Re: Final Plat S/D 88-44 - PARALLEL ESTATES

STAFF REPORT
(Final Plat; Preliminary Approved 6/16/88)

CASE NUMBER: S/D 88-44 - PARALLEL ESTATES
OWNER/APPLICANT: Eston Ash, 542 Colby, Valley Center, KS 67147
SURVEYOR/ENGINEER: Baughman Company, P.A.
LOCATION: South side of 77th Street North, in an area east of Hillside.
SITE SIZE: 33.3 Acres
NUMBER OF LOTS:
Residential: 6
Office:
Commercial:
Industrial:
Total: 6
MINIMUM LOT AREA: 218,015 Sq. Ft.
CURRENT ZONING: "R"
PROPOSED ZONING: "R"

Re: Preliminary Plat S/D 88-44 - PARALLEL ESTATES

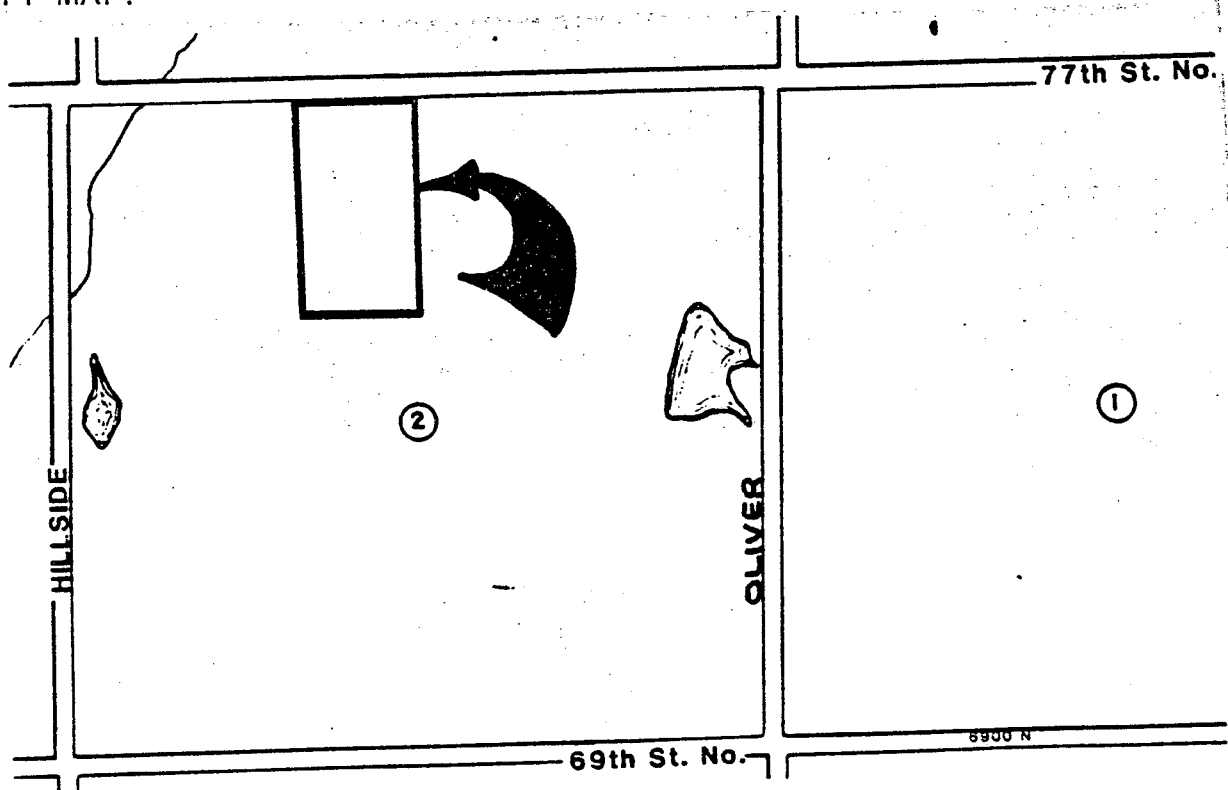
- A. Since neither municipal water nor sanitary sewer is available to serve this property, the applicant shall contact the Environmental Health Division of the Health Department to find out what tests may be necessary and what standards are to be met for approval of on-site sewerage facilities and water wells. A memorandum shall be obtained specifying approval.

- B. The applicant shall guarantee the construction of Walters Circle to suburban street standards.
- C. The applicant shall provide proof, by letter from the Texaco Pipeline Company or by copy of the pipeline easement agreement, that the dedication of street right-of-way over a portion of the pipeline easement and the use of part of this pipeline easement as a general utility easement are acceptable and that the building setback line as shown is sufficient. Any relocation, lowering or encasement of the pipeline, caused by development of this property, will not be at the expense of the County.

- D. The final plat tracing shall indicate the recording information for the 50-foot pipeline easement on this property.
- E. The final plat shall indicate the amounts of half-street rights-of-way adjacent to the plat as well as the amount of additional rights-of-way being dedicated by this plat for 77th Street North. The final tracing shall also indicate the amount of street right-of-way being dedicated for Walters Circle.

- F. Since this property involves the platting of a limited number of large lots (5 acres and over), it is recommended that the requirements of Section 7-201(R) be modified to permit the platting of Walters Circle with 1000 feet of length.

- G. The Soil and Conservation Service has advised that this property has a developed systems of terracing on it. The applicant is advised that care should be taken when the terracing is removed in order to avoid undo soil erosion.

- H. On the final plat, a 35-foot building setback shall be indicated on Lots 1 and 6 from 77th Street North. Also, a 30-foot building setback shall be indicated on Lots 1, 2, 3, 4, 5 and 6 from Walters Circle.

- I. To receive mail delivery without delay, and to avoid unnecessary expense, the applicant is advised of the necessity to meet with the U.S. Postal Service Growth Management Coordinator (phone 316-946-4527) prior to development of the plat so that the type of delivery, and the tentative mailbox locations can be determined.

- J. The applicant's engineer is advised that the Register of Deeds is requiring the name(s) of the notary public, who acknowledges the signatures on this plat, to be printed beneath the notary's signature.

- K. The applicant shall install or guarantee the installation of all utilities and facilities which are applicable and described in Article 8 of the MAPC Subdivision Regulations.
- L. Requirements for a final plat (see pages 20-25, Part 4, Article 5 of the MAPC Subdivision Regulations).
- M. Perimeter closure computations shall be submitted with the final plat tracing. Section 5-101(C).
- N. Recording of the plat within 30 days after approval by the City Council.
- O. The representative from County Engineering should be prepared to comment on the status of the applicant's drainage plan.

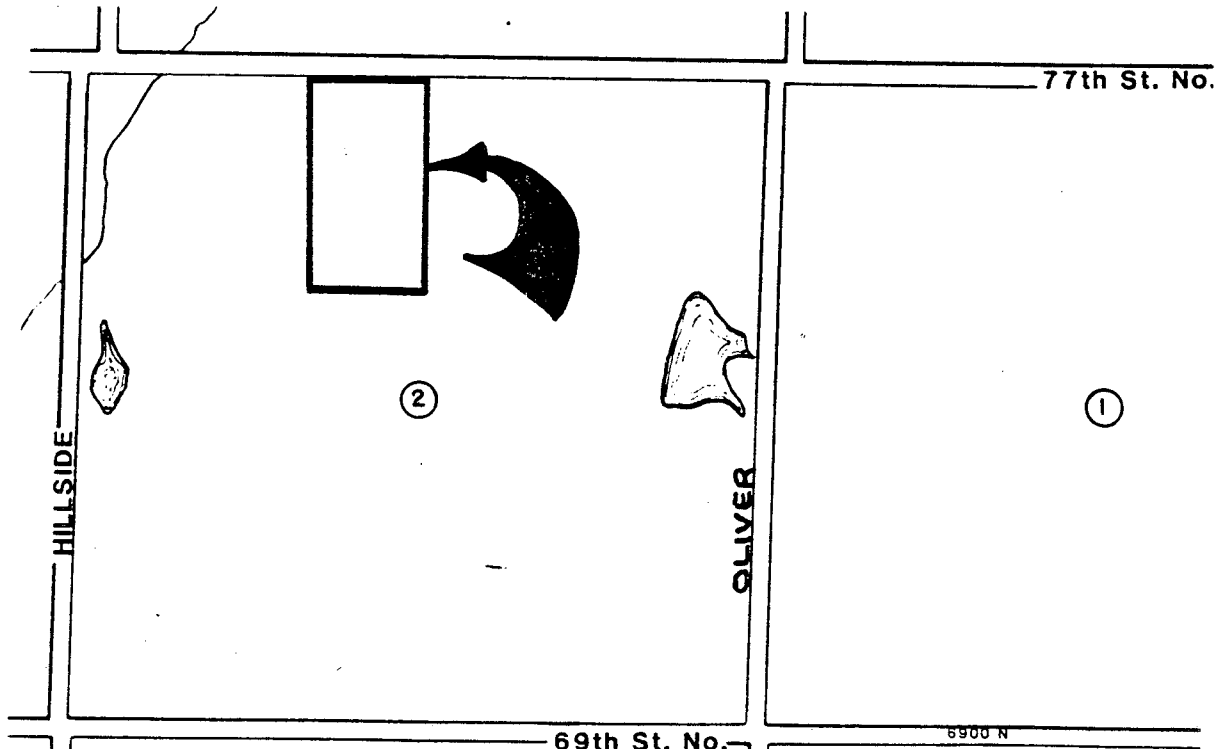
- A. Since neither municipal water nor sanitary sewer is available to serve this property, the applicant shall contact the Environmental Health Division of the Health Department to find out what tests may be necessary and what standards are to be met for approval of on-site sewerage facilities and water wells. A memorandum shall be obtained specifying approval.

- B. The applicant shall guarantee the construction of Walters Circle to suburban street standards.
- C. The applicant shall provide proof, by letter from the Texaco Pipeline Company or by copy of the pipeline easement agreement, that the dedication of street right-of-way over a portion of the pipeline easement and the use of part of this pipeline easement as a general utility easement are acceptable and that the building setback line as shown is sufficient. Any relocation, lowering or encasement of the pipeline, caused by development of this property, will not be at the expense of the County.

- D. The final plat shall indicate the recording information for the 50-foot pipeline easement on this property.
- E. On the final plat, the pipeline easement shall be dimensioned from lot corners.

- F. Since this plat involves the platting of a floodway, the platator's text on the final plat shall reference the standard floodway language.
- G. On the final plat, angles or bearings and distances shall be indicated for the perimeter of the proposed floodways.

- H. The platting of the minimum building pad elevation shall be noted on the face of the plat as well as in the platator's text.
- I. As this property is establishing minimum building pad elevations, the face of the plat shall reference the location and elevation of permanent on-site and off-site benchmarks. Section 5-402(N).

- J. Since this property involves the platting of a limited number of large lots (5 acres and over), it is recommended that the requirements of Section 7-201(R) be modified to permit the platting of Walters Circle with 1000 feet of length.

- K. On the final plat, the centerline of 77th Street North shall be labeled.
- L. Prior to, or at the time of submitting the final plat, the applicant shall submit a drainage plan to County Engineering for review and approval.

- M. To receive mail delivery without delay, and to avoid unnecessary expense, the applicant is advised of the necessity to meet with the U.S. Postal Service Growth Management Coordinator (phone 316-946-4527) prior to development of the plat so that the type of delivery, and the tentative mailbox locations can be determined.

- N. The applicant's engineer is advised that the Register of Deeds is requiring the name(s) of the notary public, who acknowledges the signatures on this plat, to be printed beneath the notary's signature.

- O. The applicant shall install or guarantee the installation of all utilities and facilities which are applicable and described in Article 8 of the MAPC Subdivision Regulations.

- P. Requirements for a final plat (see pages 20-25, Part 4, Article 5 of the MAPC Subdivision Regulations).
- Q. The representative from County Engineering should be prepared to comment on the status of the applicant's drainage concept.
